STATE PROJECT NO. 214-01-0015
FEDERAL AID PROJECT NO. 5709(501)
WEST JCT. LA 343 - JCT. US 167
ROUTE LA 699
VERMILION PARISH

SUBJECT: ADDENDUM NO. 1 (CONSTRUCTION PROPOSAL REVISION)
ELECTRONIC BIDDING AMENDMENT NO. 1

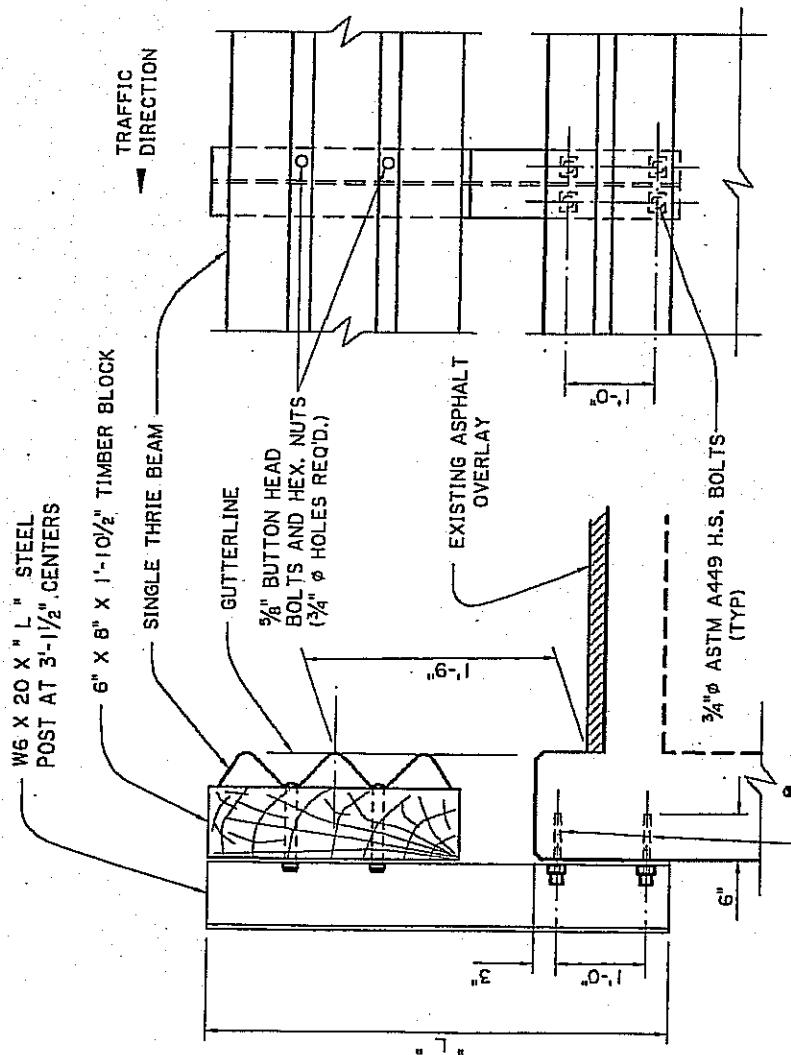
BRIDGE AND STRUCTURAL DESIGN		STANDARD DETAIL		SIDE MOUNT GUARD RAIL (FOR BOX CULVERT)				DESIGNED CHECKED DETAILED CHECKED DATE SHEET		PARISH FEDERAL PROJECT STATE PROJECT		Vermon 214-01-0015	
										J. BENTON P. FOSSIER		12-2008		214-01-0015	
										Add sheet 6/15/09		-cbd BY		REVISION DESCRIPTION

ALL WORK AND MATERIALS REQ'D. TO INSTALL GUARD RAIL ON BOX CULVERTS SHALL BE PAID FOR UNDER ITEM 704-01-01000 GUARD RAIL (SINGLE THREE BEAM) (3'-1 1/2" POST SPACING).

DRILL 1" ϕ HOLES, 6" DEEP AT THE TOP AND BOTTOM (MIN.) FOR 3/4" ϕ GALVANIZED BOLT USE 3/4" GALVANIZED NUT WITH GALVANIZED CUT WASHER.

• HOLES SHALL BE FILLED WITH EPOXY INJECTION SYSTEM AS LISTED ON CPL 40. PLACE BOLT IN HOLES IMMEDIATELY AND WAIT FOR MANUFACTURERS CURE TIME.
